# INDIAN RAILWAY BRIDGE MANUAL

## ADVANCE CORRECTION SLIP NO.12 DATED 18.12.2007

## ADVANCE CORRIGENDUM SLIP NO. 18 DATED 17.12.2008

### **224 Dismantling of arch bridges:**

SECTIONAL ELEVATION  
Fig. 1(a)

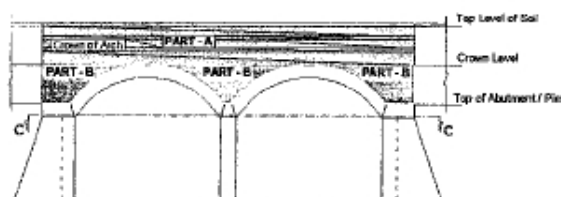
(i) Divide the depth of soil into two parts, i.e. **Part 'A'** from top of soil to the depth up to the level of Crown of arch. **Part 'B'** is from Crown level to the top of Abutment / Pier as shown in Fig. 1(a).
